Access Compliance Report

Public Rights-of-Way

(Curb Ramps)

Intersection ID: 32270	Main Street: SPRINGWELL_ST	Cross Street: LANCASTER_HY	Location: S
ADA ID: 8FD915D83688	Ramp Type: PerpDiag	Initial Pass/Fail: Fail	Overall Compliance: No
			Severity Score: 21.25

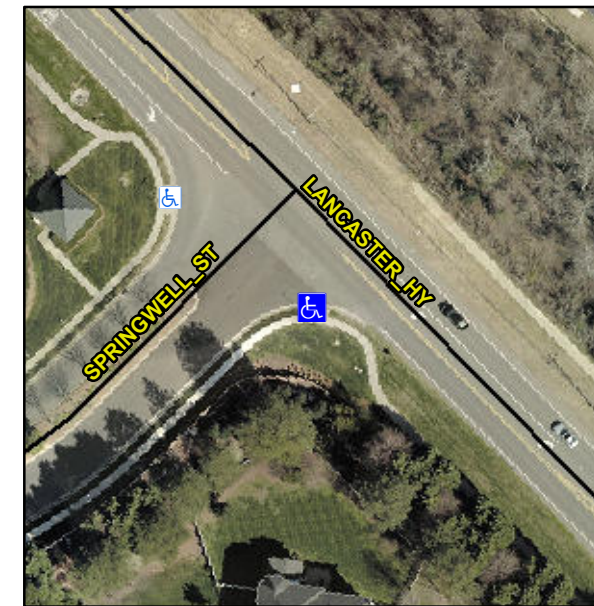
Not Found, R304.5.1, R304.2.2

Compliance	Description	Data	Compliance	Description	Data
N/A	Ramp Length (in)	48.0	No	Ramp Slope (%)	11.1
No	Ramp Width (in)	43.0	Yes	Ramp XSlope (%)	1.3
N/A	Flare Type LT	N/A	N/A	Flare Type RT	N/A
N/A	Flare Slope LT (%)	N/A	N/A	Flare Slope RT (%)	N/A
N/A	Flare Traversable LT?	N/A	N/A	Flare Traversable RT?	N/A
N/A	Landing Length (in)	N/A	N/A	DWS Provided?	N/A
N/A	Landing Width (in)	N/A	N/A	DWS Contrast?	N/A
N/A	Landing Slope (%)	N/A	N/A	DWS Length (in)	N/A
N/A	Landing X Slope (%)	N/A	N/A	DWS Full Width?	N/A
N/A	Landing Curb? (Y/N)	N/A	N/A	DWS Offset (in)	N/A
N/A	Shared Landing?	N/A			
N/A	Gutter Ponding?	N/A	N/A	Gutter Slope (%)	N/A
N/A	Gutter Lip Ht (in)	N/A	N/A	Gutter X Slope (%)	N/A
N/A	Painted X Walk1?	No	N/A	Painted X Walk2?	No
	X Walk 1 Direction	To NE		X Walk 2 Direction	To NW
N/A	X Walk 1 Width (in)	N/A	N/A	X Walk 2 Width (in)	N/A
	X Walk 1 Slope (%)	1.2		X Walk 2 Slope (%)	2.5
	X Walk 1 X Slope (%)	3.9		X Walk 2 X Slope (%)	0.8

Remove & Replace Curb Ramp With Two New Directional Ramps or Equivalent.
